RAIN WATER HARVESTING IN LDPE LINED PONDS

TAL: DHANDHUKA DIST: AHMEDABAD

The World Bank Supervision Mission during its visit to Gujarat in November 1998 agreed for the work of construction of ponds (Rain water harvesting structures). The work was entrusted to Uthan N.G.O working in that area.

PLATE-4
GENERAL LAYOUT OF POND, GUIDE
BUND FILTER & CATTLE TROUGH

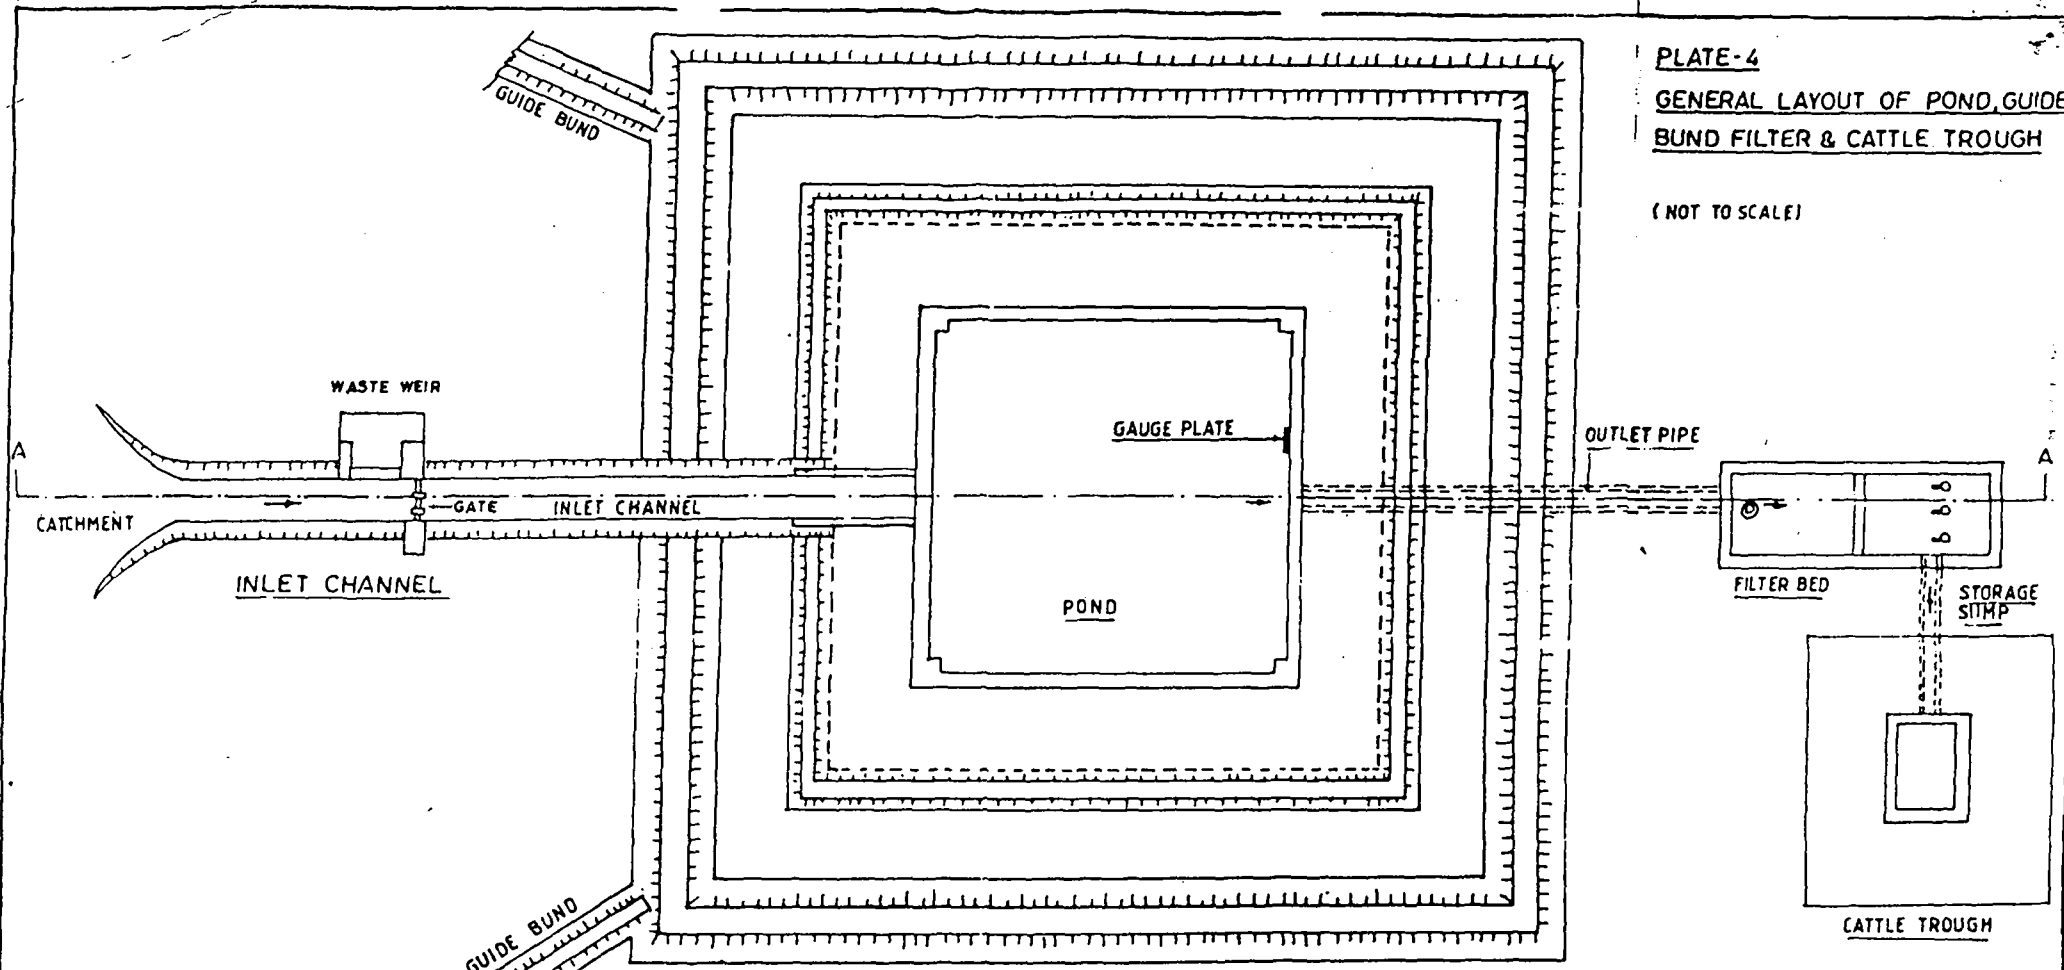
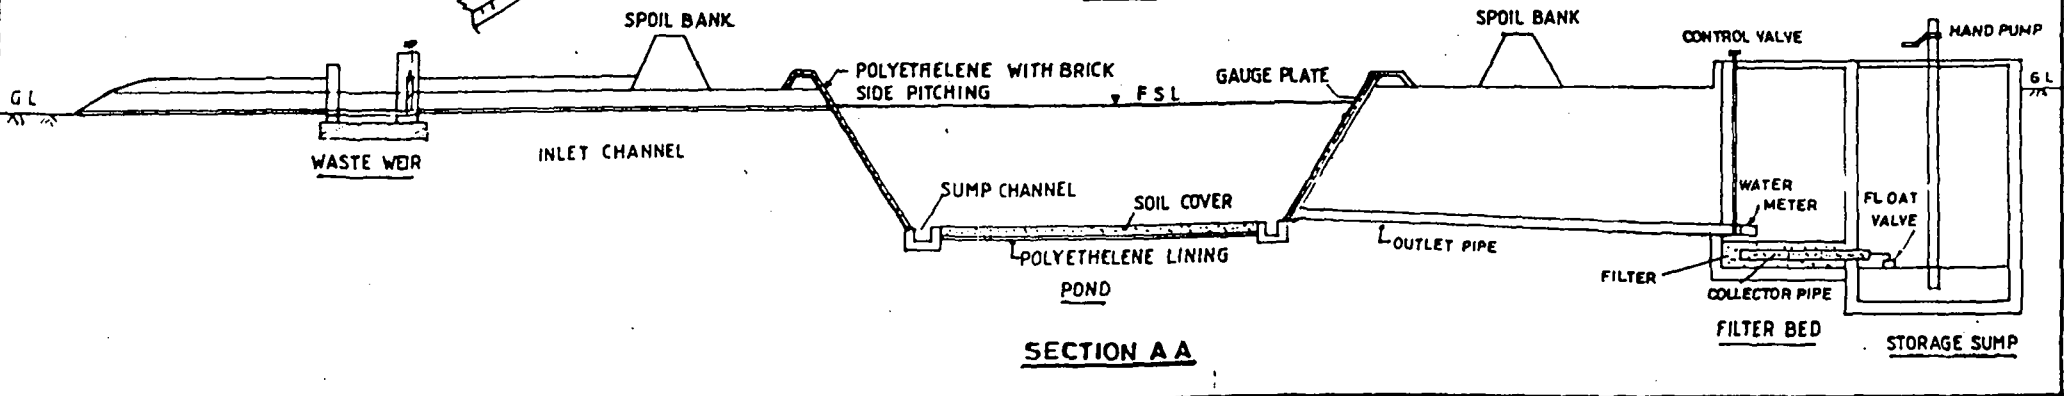
From the results it was concluded that there are certain limitations and drawbacks of the LDPE lined ponds which are narrated as under :

1. Soil of this area is saline. Hence rain water which is collected in the ponds as runoff + carry salinity of soil with it. Thus water being collected in the ponds it self is saline.

2. In this dry area loss of water by evaporation during the year is about 2 metres. Due to evaporation the concentration of salinity in the pond increases with time. As a result in summer the quantity of water left in the pond will be too less and salinity will be more. Thus quality of water will not be fit for drinking purpose.

3. Moreover pond water always be bacteriologically unfit for drinking purpose. Filter unit installed on the side of the pond will be not so efficient to remove so high bacteriological load. There will be about 0.6., head loss in the filter beds. In summer depth of water will be 1 m or less. Hence sufficient head will not be available for proper functioning of the filter unit.

4. Water table in this area remains 2 m to 3 m below ground level- The bed of the pond should be kept sufficiently above water table. If this condition is observed depth of pond will have to be restricted to 2 m. But as evaporation losses during year are 2m no water will be left in the pond during summer. If the depth is kept 3-5 to 4.0 m there will be possibility of lifting plastic. due to uplift pressure of under ground water when pond is empty. Due to this uplift pressure of plastic is damaged the main

5. Soil of this area is black cotton soil. Behaviour of this soil is such that volume increases when wet and decreases when dry and as a result cracks are developed in the soil. This behaviour results in unequal settlement of the components resting on it. Due to this unequal settlement lining and plastic are damaged.

If ponds are dewatered in the end of summer and rain is delayed people will have to remain without water when it is badly required because forecasting of monsoon will never be so perfect. Due to increase in salinity of water in the ponds sweet soil spread on the plastic at bed also turns saline. This soil also requires to be replaced by sweet soil. Cost of sweet soil comes to about Rs 40,000 to Rs. 45,000. During removal of sweet soil there is all the possibility of damaging of plastic. This damaged plastic also requires to be repaired and replaced. All these will add considerably to the maintenance cost.
